Re: Conde Water System Improvements  
Conde, South Dakota  
A-6352

### **ADDENDUM NUMBER 1**

# SECTION 33 05 23.16 – UTILITY PIPE JACKING

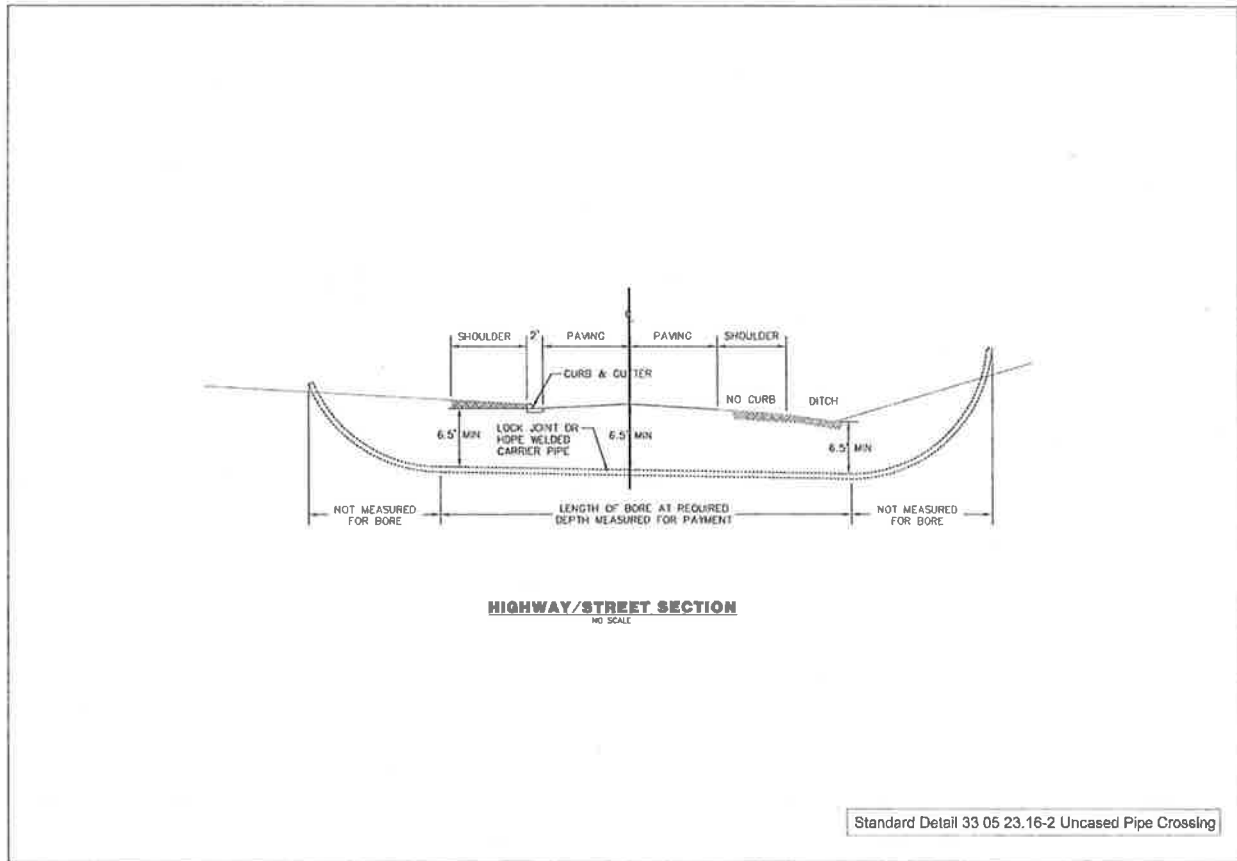
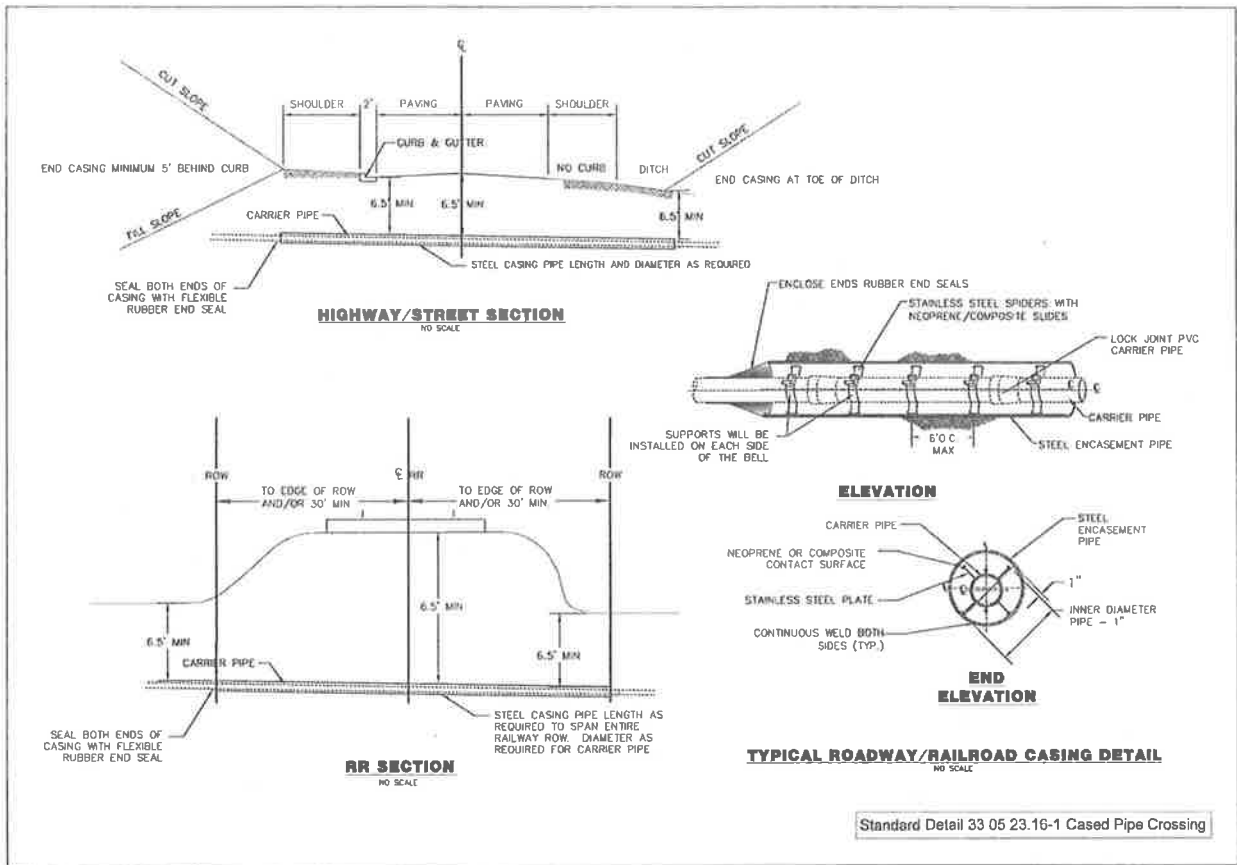
16. PART 2, Division 33 00 00, Section 33 05 23.16: Add the attached section to the specifications
